Item 4.9.15 of the provisional agenda

## **Proposal for Supplement 2 to the 03 series of amendments to UN Regulation No. 113 (Headlamps emitting a symmetrical passing-beam)**

### **Submitted by the Working Party on Lighting and Light-Signalling\*, \*\***

"Figure C

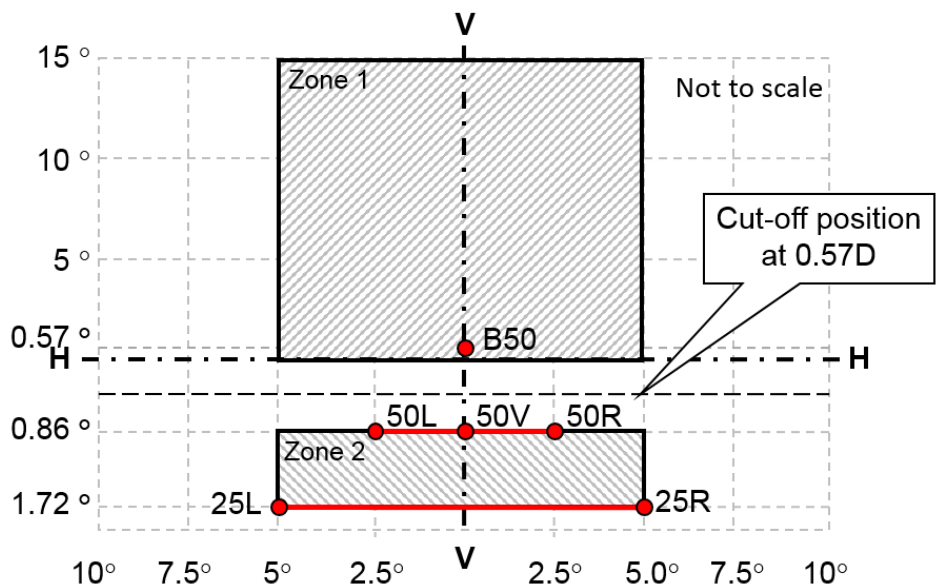
Annex 3

Figure C, amend to read:

Passing beam test points and zones for Class B headlamp(s):
